**STREAMLINED REMEDIATION SYSTEM EVALUATION (RSE-LITE)
FOR A GROUND WATER PUMP AND TREAT SYSTEM**

**EATON CORPORATION FACILITY
KEARNEY, NEBRASKA**

DECEMBER 9, 2005

EPA 542-R-05-024
December 2005
www.epa.gov/tio
clu-in.org/optimization

Job No. 16169881		DIRECT PUSH SAMPLING LOCATIONS AND TCE PLUME	Figure 2-1
	Direct Push Groundwater Investigation Eaton Corporation Kearney, Nebraska

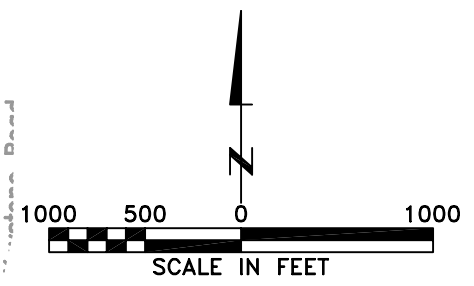
- The direct-push investigation conducted in February 2005 indicated that TCE contamination is present downgradient of extraction wells EW-3 and EW-4 and downgradient of areas where TCE was previously observed in 2002. However, it is

possible that this contamination was present before 2002 and before the installation of EW-3 and EW-4. For example, in December 2002, the furthest downgradient samples were collected from GS-107, GS-108, and GS-109 where TCE concentrations were 11 ug/L, 7 ug/L, and 8 ug/L, respectively. Therefore, the TCE concentrations that were observed downgradient of these locations in 2005 at GS-208 (5.1 ug/L) and GS-209 (7.6 ug/L) could have already been present. For this reason, the RSE-lite team does not believe that this downgradient contamination recently observed in 2005 is an indication of insufficient capture provided by EW-3 and EW-4. Furthermore, the concentrations are so close to the standard of 5 ug/L that additional remedial effort (e.g., additional pumping) in this area would likely provide a negligible improvement in remedy effectiveness.

To evaluate plume capture, the site team should consider conducting limited direct-push sampling events on an annual basis for three years. The events should be limited to five

locations (i.e., a one-day event) with sampling locations in the vicinity of GS-208, GS-209, and GS-210 plus GS-206 and GS-212. The data from the various events can be compared to determine if there is a consistent trend. A consistent increase in concentrations near GS-208 through GS-210 would suggest that capture is inadequate, and a consistent decrease would suggest that capture is adequate. Similarly, a consistent increase near GS-206 and GS-212 might suggest that the plume is migrating to the southeast. The potentiometric surface maps proposed in Section 4.1.2 of this report would help confirm this potential change in the migration direction.
